U. S. NUCLEAR REGULATORY COMMISSION
OFFICE OF INSPECTION AND ENFORCEMENT

Report No. 50-333/81-05

Facility Name: James A. FitzPatrick Nuclear Power Plant (JAF)

Inspection on February 9-13, 24-27, 1981 (Report No. 50-333/81-05)

Iodine-131 Airborne Release Rates from Nine Mile Point/J.A.FitzPatrick Plants : September - November 1980

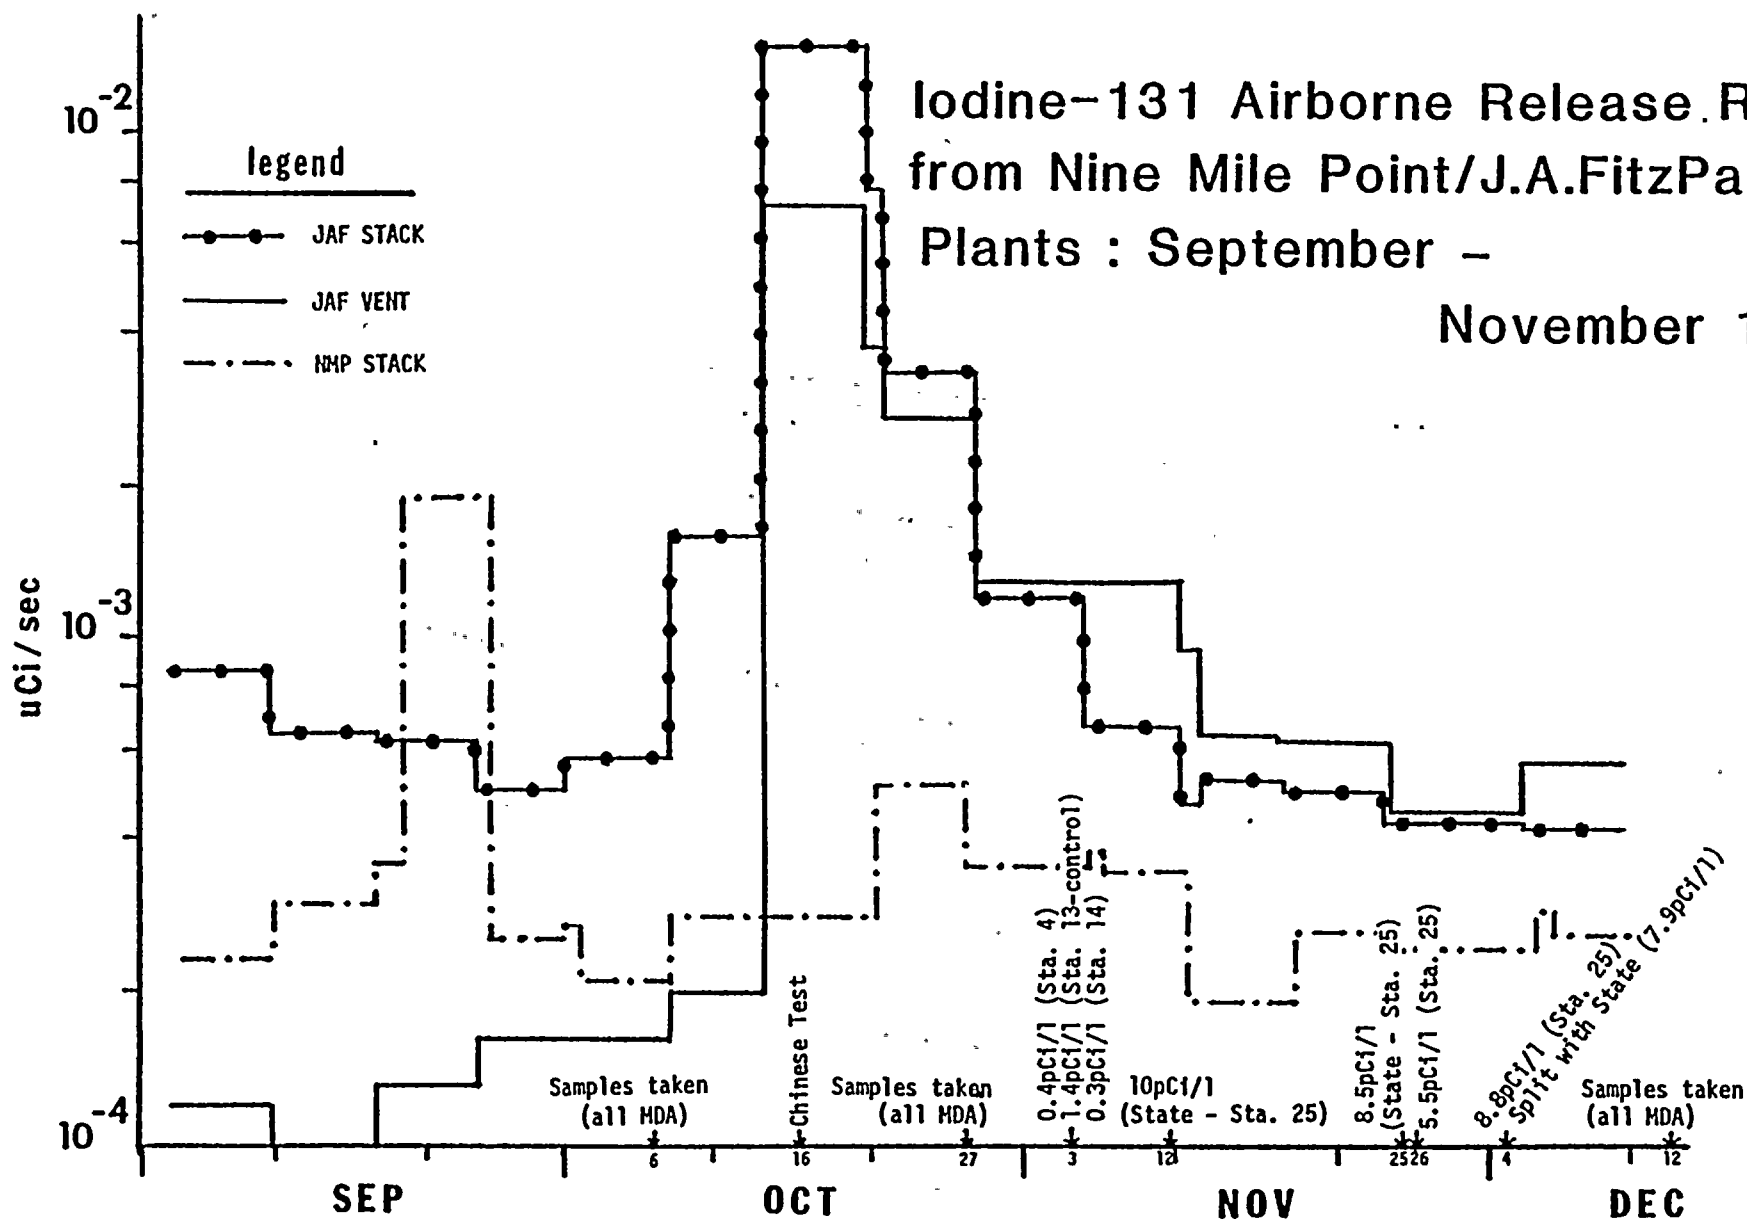
The attachment to this report illustrates the airborne iodine-131 releases from both the NMP and JAF sites during the interval September through November 1980. Also shown on the same plot are the date of the weapons test by the Peoples Republic of China on October 16, 1980, and the dates, locations and the I-131 results of all milk samples with positive values. The maximum airborne release rate (from JAF) for I-131 occurred during the week in which the weapons test occurred. Because of the near proximity of the JAF-NMP source to the sampled milk farms, any deposition from this source should have taken place within hours of the release. Deposition from the weapons test, on the other hand, would first be expected to occur approximately two weeks after the test because of the atmospheric diffusion and transport time. The deposition from the latter would also be distributed in time over several weeks.

Review of the milk data (as depicted in the attachment) has indicated that the first positive iodine measurements in milk occurred approximately two weeks following the weapons test at which time the iodine release rates from both NMP and JAF plants had decreased by a factor of about 10. These positive milk I-131 samples were collected from several locations including the control farm. Subsequent to this date (November 3, 1981), all sampled milk cattle in the area (with the exception of Sampling Station No. 25) were removed from pasture for the winter. Sample Station No. 25 showed an increase in I-131 levels in milk to 10 pCi/l and remained at about that level (about 8 pCi/l) until the end of November, while the NMP-JAF releases continued at about a factor of 20 below the peak release rate.

Consequently, while one cannot easily rule out that the NMP-JAF releases contributed to the I-131 activities measured in three milk samples, it appears at least highly unlikely that these releases were the sole source of the measured activity. Regardless of the source of the I-131 the expected dose consequences would be minor. Only one cow was present at Station No. 25 where the elevated levels were detected, and consumption of this cow's milk with 10 pCi/l of I-131 for the one month period
